UNITED STATES PATENT AND TRADEMARK OFFICE

Office Action Summary

10/776,348

Church discloses a variable nozzle control apparatus adapted for a turbocharger in an engine comprising:

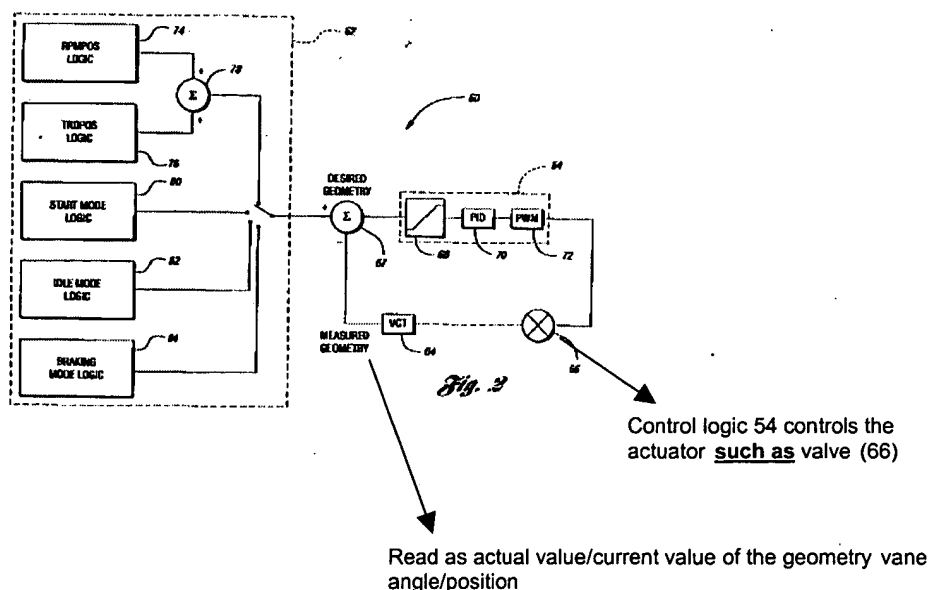
Examiner respectfully disagrees with the applicants, since:

a. First of all, in claim 1, the recitations of “for identifying an operating situation ... and outputting indication information of the vane”; “for controlling an opening ... from the electronic control unit”; “for receiving the opening indication ...and outputting an output signal”; “ for receiving the output signal...through an output shaft”; “for detecting a rotational angle... to the electronic control circuit”; “for converting the opening indication information of the vane... output shaft; “for comparing the target angle signal ... actual signal”; “for carrying out ... the comparing device; and “for inputting the output signal... the driving section” are considered as the functional language. The combination of Church and Suganami disclose all the structural components of an system, which are read on those of the instant invention. Therefore, the Church-Suganami system is capable of performing the same desired functions as the instant invention having been claimed in claim 2.

b. Secondly, Church discloses that control logic 54 controls the actuator **such as** valve (66) (in Column 6, lines 19-20), and that it is appreciated that **other types of actuator/sensor arrangement** being contemplated (in Column 6, lines 1-2). Church use the term ***“such as valve”*** and ***“other types of actuator/sensor arrangement”***, which means that the Church’s actuator can be

c. Further Church does disclose a closed control loop system 60 with a control logic (67) receiving a control signal/actual value/ current value of the vane position of the geometry turbine and comparing to the target value/desired position/desired angle of the geometry turbine. In column 5, lines 56-57, Church also discloses that "the turbocharger geometry sensor may be implemented in a variety of ways, and is preferably a cylinder integrated position sensor", which means that different kinds of sensor are used/applied in the Church system to indicate the position/angle of the vane of the geometry turbine.
